MAS004768 RU 25-28

Rapid Update 788 Grecale – USB Port Trim Check

Certain Maserati Grecale (M182) MY23 MY24 MY25 listed in MODISCS+ are involved in a Rapid Update to check the trim of the USB port in the center console.

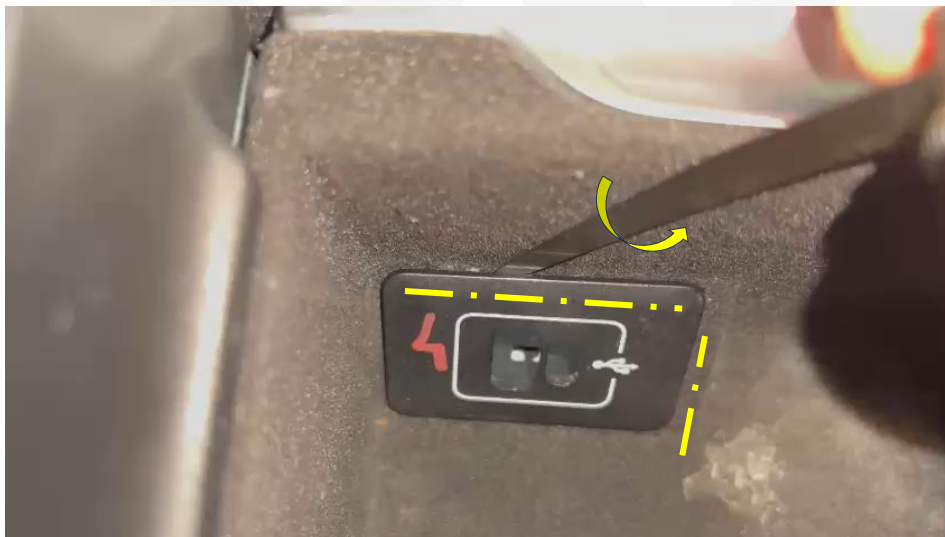
1. Always check ModisCS+ to see if the vehicle is involved in this action and if it has not been previously performed.
2. Before starting, make sure to apply adequate protection to the interior on the vehicle to avoid damage.
3. Locate the USB port in the center console storage compartment.

4. Manually move the USB port by hand to check for a secure fitment. Try and move it in all directions to see if it feels loose or lifts.
5. Use a 3mm thick plastic trim tool or feeler gauge:
Gently try to insert it between the trim and the storage compartment wall (top and right sides).
- Use a light rotary motion—do not force the tool.
⚠ Be careful not to scratch the trim or interior.

6. Evaluation:
 - If the gauge doesn't fit and the trim is secure → Vehicle is OK.
 - If the trim lifts or detaches → Replace the trim.
7. Reassemble all parts in reverse order after replacement.
8. Procedure complete.
